**From:** Graczyk, Lisa [mailto:graczyk.lisa@epa.gov]  
**Sent:** Wednesday, May 23, 2018 5:57 PM  
**To:** Sylwia Scott <Sylwia.Scott@usecology.com>  
**Cc:** Greensley, Jean <greensley.jean@epa.gov>; Quackenbush, Peter (DEQ) (QUACKENBUSHP@michigan.gov) <QUACKENBUSHP@michigan.gov>; Blough, James <Blough.James@epa.gov>  
**Subject:** Clarification on Response to EPA's May 14, 2018 Comments

## Response to EPA’s May 23, 2018 Comment

## Response to EPA's May 30, 2018 Comment

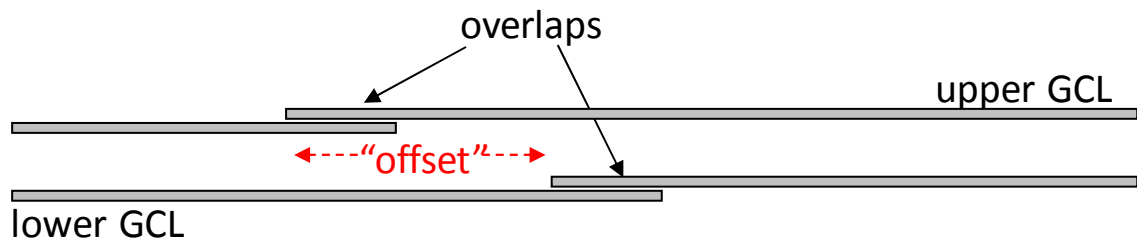
Can you clarify what is meant by “offsetting” in the response?

Both the primary and the secondary liners have two layers of GCL. As shown in the sketch below, each roll of GCL will overlap the adjacent roll by six inches. WDI will ensure that each overlap in the upper GCL does not vertically coincide with any overlap in the lower GCL.
